Access Compliance Report

Public Rights-of-Way

(Curb Ramps)

Intersection ID: 23633	Main Street: HILLSIDE_LN	Cross Street: LARRISA_CT	Location: SW
ADA ID: 6A86EE4B5758	Ramp Type: BlendTrans2	Initial Pass/Fail: Fail	Overall Compliance: No
		Severity Score: 8.75

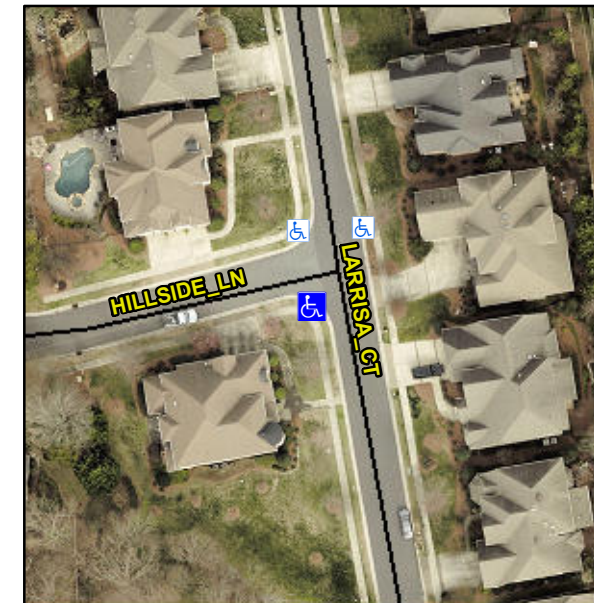
Not Found, R304.5.1

Compliance	Description	Data	Compliance	Description	Data
N/A	Ramp Length (in)	47.0	Yes	BlendTrans Slope (%)	0.5
No	Ramp Width (in)	37.0	Yes	BlendTrans XSlope (%)	1.0
N/A	Flare Type LT	N/A	N/A	Flare Type RT	N/A
N/A	Flare Slope LT (%)	N/A	N/A	Flare Slope RT (%)	N/A
N/A	Flare Traversable LT?	N/A	N/A	Flare Traversable RT?	N/A
N/A	Landing Length (in)	N/A	N/A	DWS Provided?	N/A
N/A	Landing Width (in)	N/A	N/A	DWS Contrast?	N/A
N/A	Landing Slope (%)	N/A	N/A	DWS Length (in)	N/A
N/A	Landing X Slope (%)	N/A	N/A	DWS Full Width?	N/A
N/A	Landing Curb? (Y/N)	N/A	N/A	DWS Offset (in)	N/A
N/A	Shared Landing?	N/A			
N/A	Gutter Ponding?	N/A	N/A	Gutter Slope (%)	N/A
N/A	Gutter Lip Ht (in)	N/A	N/A	Gutter X Slope (%)	N/A
N/A	Painted X Walk1?	No	N/A	Painted X Walk2?	No
	X Walk 1 Direction	To E		X Walk 2 Direction	To N
	X Walk 1 Width (in)	N/A		X Walk 2 Width (in)	N/A
	X Walk 1 Slope (%)	3.2		X Walk 2 Slope (%)	3.5
	X Walk 1 X Slope (%)	3.4		X Walk 2 X Slope (%)	3.9

N/A	Ramp inside XWalk1?	N/A	N/A	Ramp inside XWalk2?	N/A
	Road Slope (%)	1.3		Clear Space?	N/A
	Road X Slope (%)	4.8	N/A	Clear Space to XWalk (in)	N/A
N/A	Any Obstructions?	N/A	N/A	Storm Grate/Utility Hazard?	N/A
	Obstruction Type			Storm Grate/Utility Type	
		N/A			N/A
			Yes	Surface Condition? (G/P)	Good
			No	Curb Slope (%)	13.0

Remove & Replace Curb Ramp With Two New Directional Ramps or Equivalent.
